Access Compliance Report

Public Rights-of-Way

Intersection ID: 49195	Main Street: GRAYPARK_DR	Cross Street: DERITA_WOODS_CT	Location: NW
ADA ID: 085A91D75AEC	Ramp Type: PerpDiag	Initial Pass/Fail: Fail	Overall Compliance: No
		Severity Score: 12.5

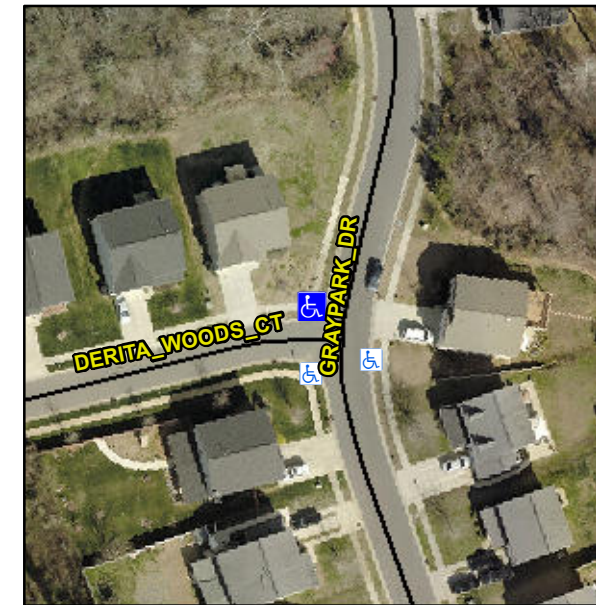
Not Found, R304.5.3

Compliance	Description	Data	Compliance	Description	Data
N/A	Ramp Length (in)	48.0	Yes	Ramp Slope (%)	5.1
Yes	Ramp Width (in)	48.0	No	Ramp XSlope (%)	5.9
N/A	Flare Type LT	N/A	N/A	Flare Type RT	N/A
N/A	Flare Slope LT (%)	N/A	N/A	Flare Slope RT (%)	N/A
N/A	Flare Traversable LT?	N/A	N/A	Flare Traversable RT?	N/A
N/A	Landing Length (in)	N/A	N/A	DWS Provided?	N/A
N/A	Landing Width (in)	N/A	N/A	DWS Contrast?	N/A
N/A	Landing Slope (%)	N/A	N/A	DWS Length (in)	N/A
N/A	Landing X Slope (%)	N/A	N/A	DWS Full Width?	N/A
N/A	Landing Curb? (Y/N)	N/A	N/A	DWS Offset (in)	N/A
N/A	Shared Landing?	N/A			
N/A	Gutter Ponding?	N/A	N/A	Gutter Slope (%)	N/A
N/A	Gutter Lip Ht (in)	0.5	N/A	Gutter X Slope (%)	N/A
N/A	Painted X Walk1?	No	N/A	Painted X Walk2?	No
	X Walk 1 Direction	To SW		X Walk 2 Direction	To SE
N/A	X Walk 1 Width (in)	N/A	N/A	X Walk 2 Width (in)	N/A
	X Walk 1 Slope (%)	5.4		X Walk 2 Slope (%)	1.2
	X Walk 1 X Slope (%)	2.9		X Walk 2 X Slope (%)	4.1

Remove & Replace Curb Ramp With Two New Directional Ramps or Equivalent.
